## Town of Hampden

### Planning Board

Wednesday, November 14, 2018, 7:00 pm

Stearns Farm Cluster Subdivision

**SKETCH PLAN: STEARNS FARM**

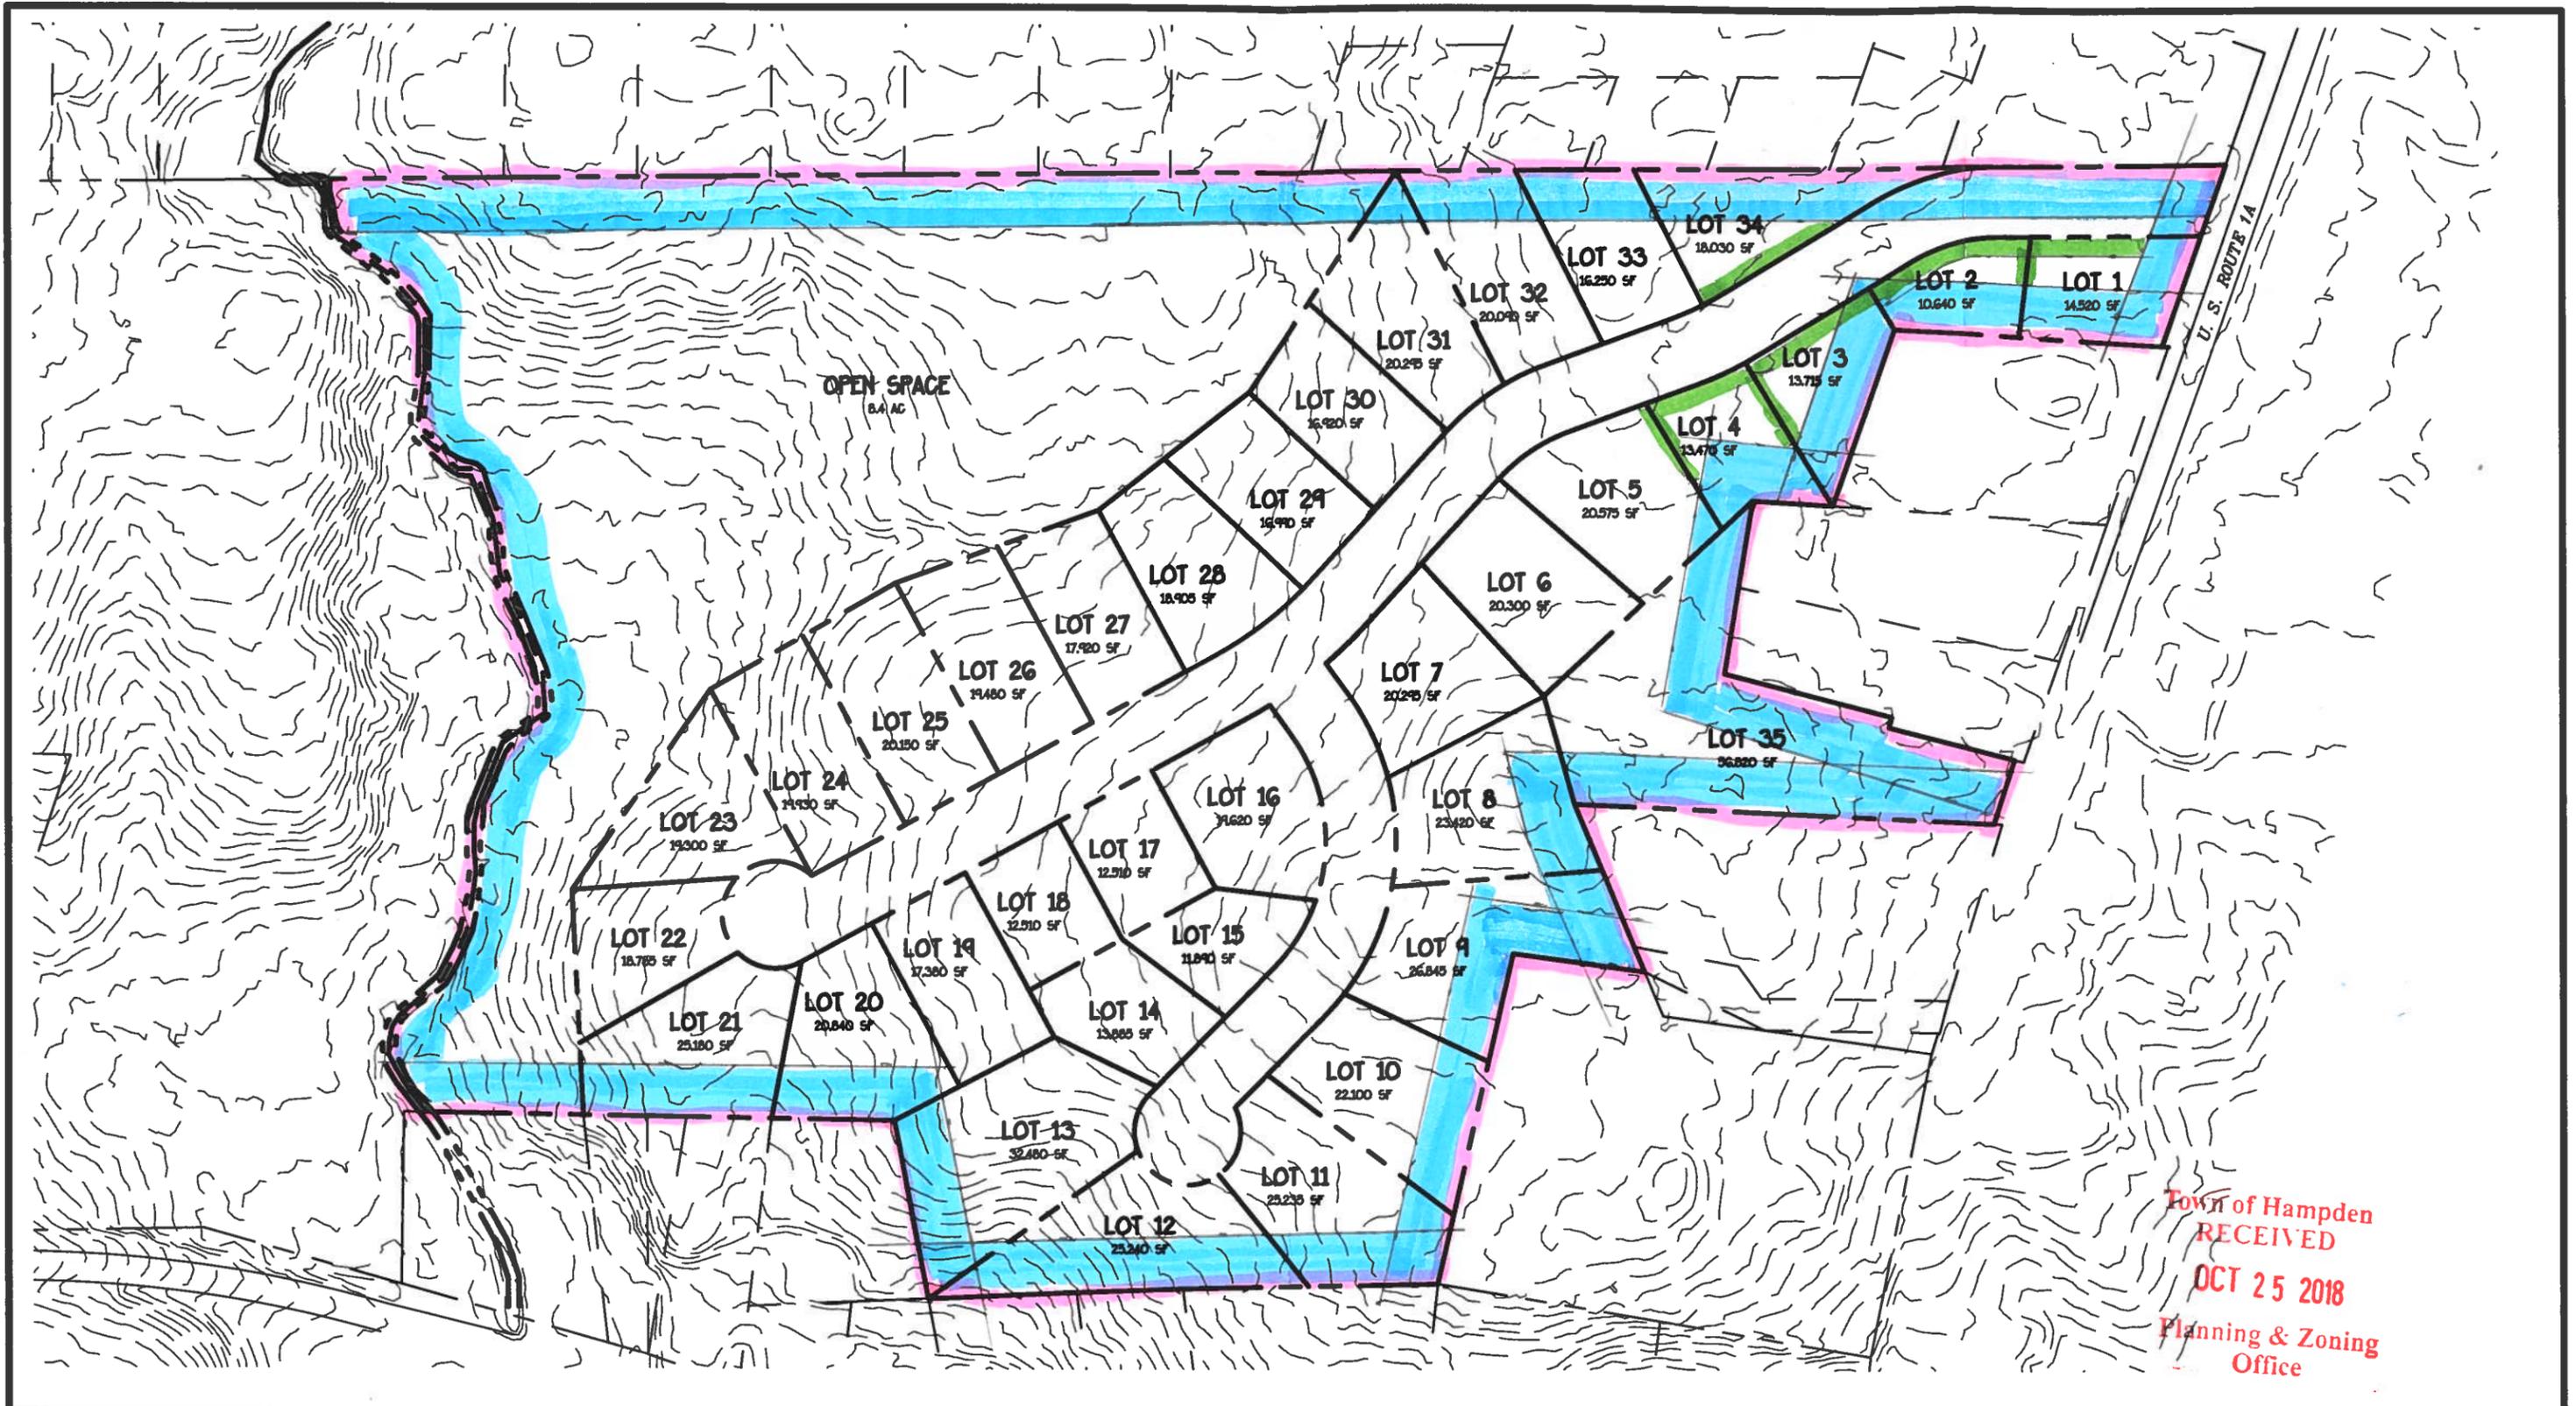
Requirement	Requirement	Comments
Tract	Min size	2 acres	Exceeds
	Min frontage	50 feet	Exceeds; frontage is located in two spots, with 55 feet at the southerly spot and roughly 205 feet at the northerly spot.
	Min buffers/setbacks (all)	50 feet	The buffer/setback area is not shown on the sketch plan but affects 18 of the lots (see attached). While there is no requirement that the buffer area be separate from individual lots, the preliminary and final subdivision plans must show the location of the buffer and there must be a deed restriction on each affected parcel to ensure that no building occurs within that area.
	Min open space	30%	Meets (30.3%)
	Max density	3 units per acre	Exceeds (1.26 units/acre)
Individ Lots	Lot size	8,000 sq ft	Exceeds (10,640 to 56,820 sq ft)
	Frontage	50 feet	All lots appear to meet, most exceed
	Front setback	20 feet	All lots should meet
	Side & rear setbacks	10 feet	All lots should meet

1. Lot 35 would not have access to the interior roadway and I question whether it should be permitted to have less than the normally required 125 feet of road frontage. It has 55 feet frontage on Main Road North, where the access would be.

2. Lot 35 has a substantial amount of buffer/setback area, extending in from Main Road North such that a driveway would need to be around 250-300 feet long to reach an area large enough to build on.

3. It is unknown if there are any wetlands on the site, if there are and they are within the open space area, no more than half the wetland acreage can be counted toward the open space requirement.

4. The road entrance is located within the tract buffer – this is allowed by §4.6.4.2 provided no portion of the roadway is located closer than 25 feet to the tract boundary. Given the intent of the buffer to protect adjacent residential development and the narrowness of the tract where the entrance is located, a better design would eliminate lots 1 and 2 and move the road to the center of that frontage on Main Road North. If that area was considered open space, and smaller lots were created, the two lots could be located elsewhere. Note that §570 of the Subdivision Ordinance also allows the Board to require a buffer, but is not required.

5. Section 551.7 of the Subdivision Ordinance says that whenever possible, subdivisions with 15 lots or more should have at least two entrances to public roads. The only way that could happen here is if the Board granted a waiver to the requirement for a 66 foot right-of-way and a road entrance was built in the location of proposed Lot 35 (55 feet frontage). That would be about 575 feet from the main entrance, both on Main Road North. The benefit would be to provide a second means of access to the subdivision in the event one entrance was blocked for any reason.

6. There is a sewer line running through the open space area, installed in the early 1980's. There are two agreement/easements (one for each parcel) recorded at the registry of deeds, book 3274, page 171 and at book 3288, page 192. The subdivision plan should show the location of this line (if necessary, town staff can go into the field to locate the manholes with GPS and provide to the applicant). While the existing agreements specify no permanent structures are to be placed within five feet of the center line of the sewer line, and while the sewer line appears to be entirely within the open space parcel of the proposed subdivision, it may be prudent to include in the open space documents that no permanent structures are to be built or erected within some greater distance than five feet.
